HC-SB-61-346

**Propeller - Pitch Change Knob Inspection, Rework, and
Introduction of an Improved Pitch Change Knob Bracket**

January 05, 2023

This page transmits Revision 3 to Service Bulletin HC-SB-61-346.

Pitch Change Knob Bracket Modification
Figure 6

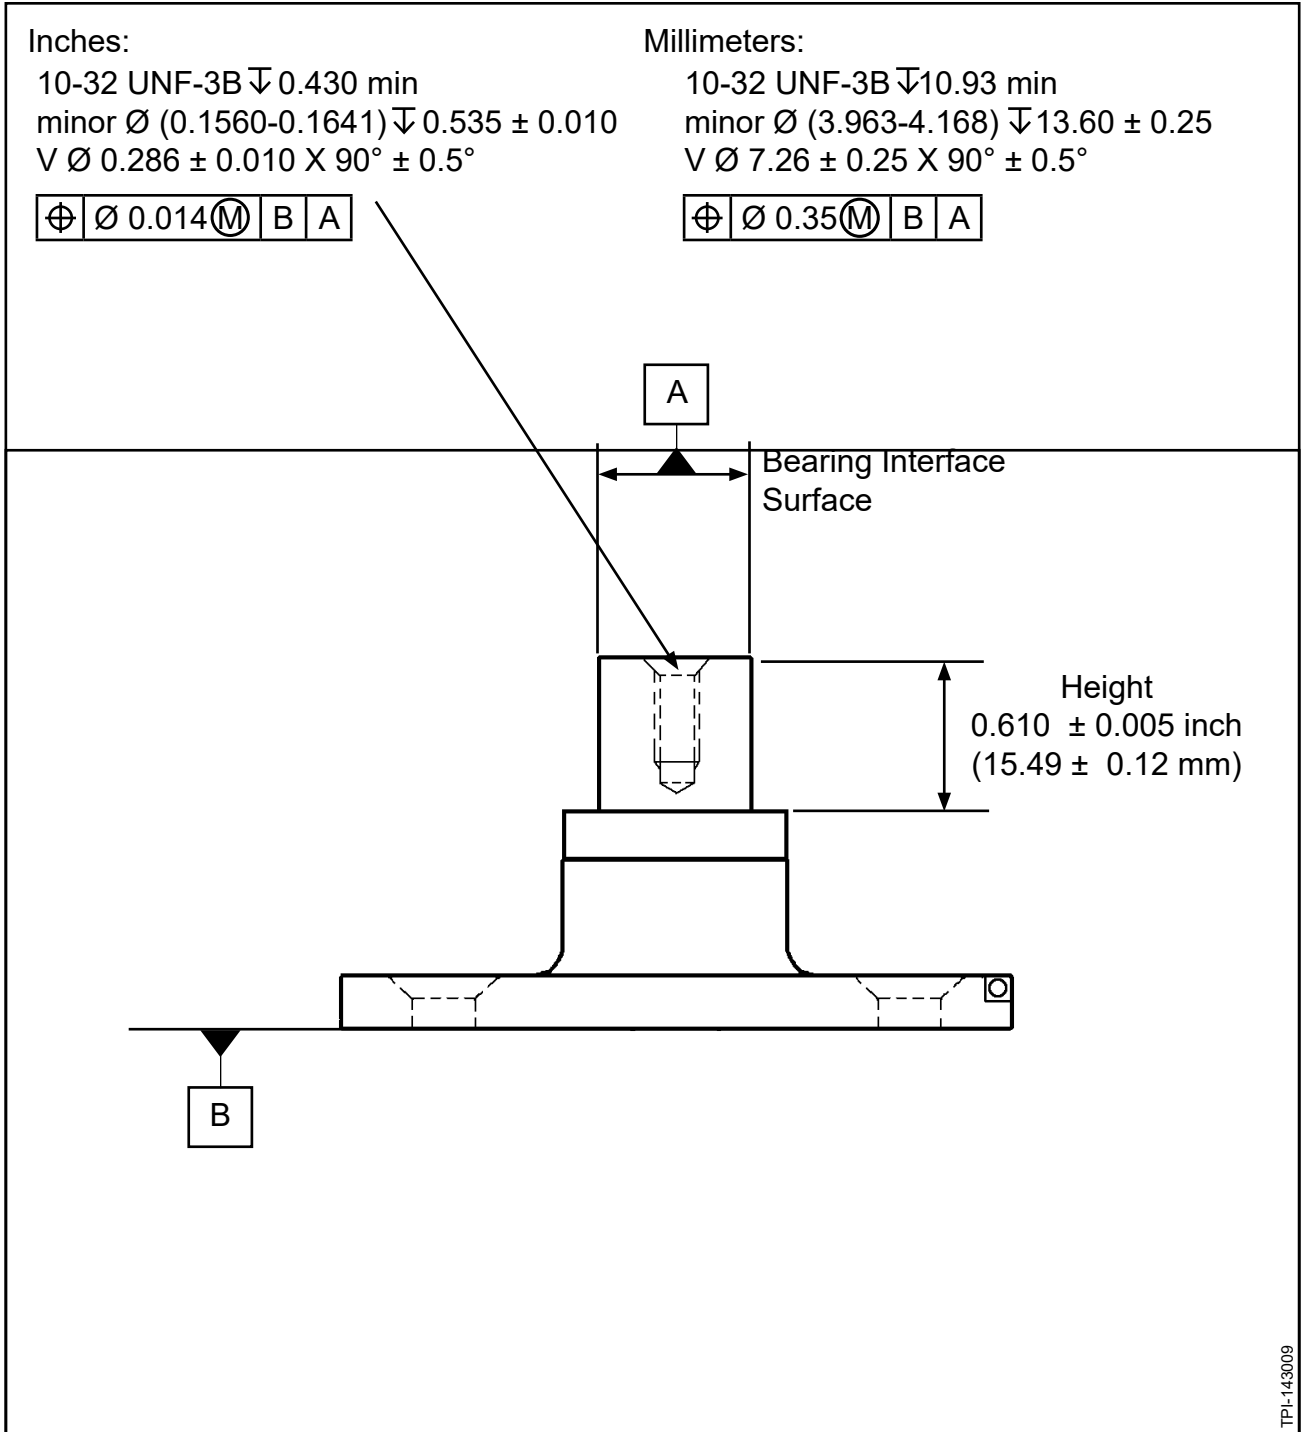
C. Pitch Change Knob Bracket Modification - Refer to Figure 6

(a) Mill off the retaining washer shoulder of the pitch change knob bracket to the height given in Figure 6.

(b) Drill, thread, and countersink/chamfer to the dimensional and true position requirements as specified in Figure 6.

(f) Inspect all machined dimensions and true position requirements in Figure 6 to make sure that all specified modification requirements have been met.
